PECO NUCLEAR

Subject: Peach Bottom Atomic Power Station, Units 2 and 3
License Change Application ECR 99-01744
Revision of Ventilation Filter Testing Program for GL 99-02

**LICENSE CHANGE APPLICATION
ECR 99-01744**

**"Revision of Ventilation Filter Testing Program
In Accordance With Generic Letter 99-02"**

Unit 2
5.0-13

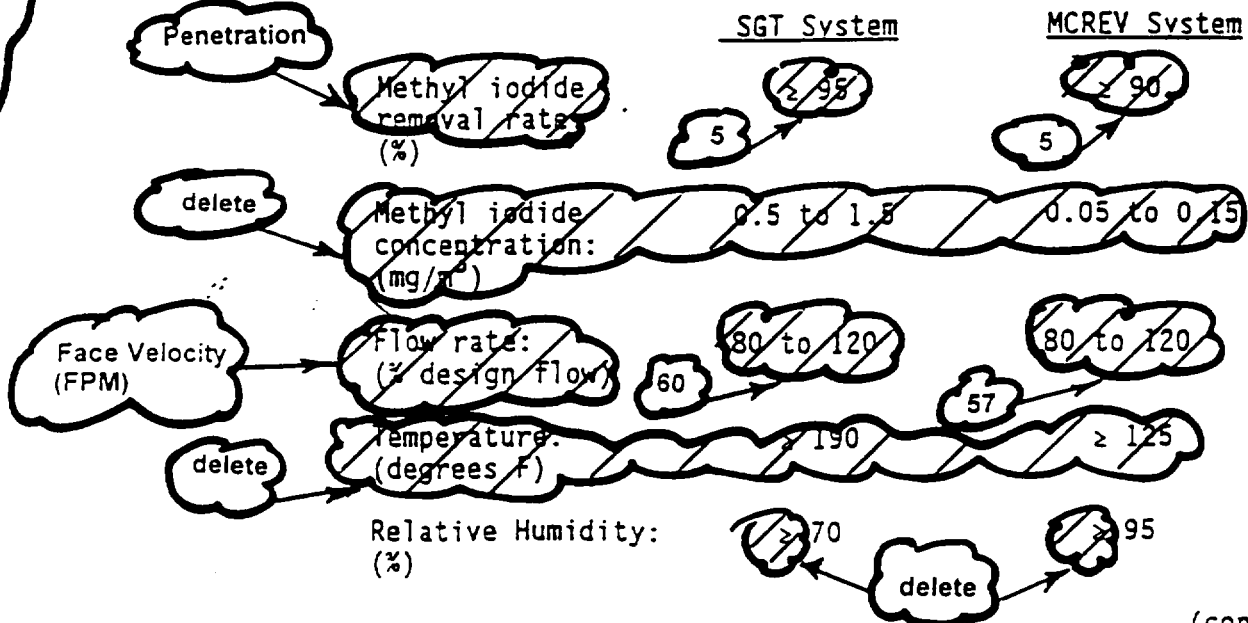
- c. Demonstrate for each of the ESF systems that a laboratory test of a sample of the charcoal adsorber, when obtained as described in Regulatory Guide 1.52, Revision 2, Section 6b, shows the methyl iodide penetration less than the value specified below when tested ~~at the conditions~~ specified below.

in accordance with the laboratory testing criteria of ASTM D3803-1989 at a temperature of 30 degrees C [86 degrees F], face velocity, and the relative humidity

1. The laboratory testing for methyl iodide penetration will be specified to be done in accordance with ASTM D3803-1989.
2. The acceptable methyl iodide removal rate will be expressed as maximum methyl iodide penetration rate. The acceptable penetration limit for the MCREV system will be changed from 10% to 5%.
3. The methyl iodide test concentrations for MCREV and SGT will be deleted from the TS. These testing parameters will be as specified by the ASTM testing standard.
4. The face velocity for MCREV and SGT will be specified in the TS per GL 99-02. GL 99-02 required systems that have face velocities greater than 110% of 40 fpm to designate the face velocity within TS.
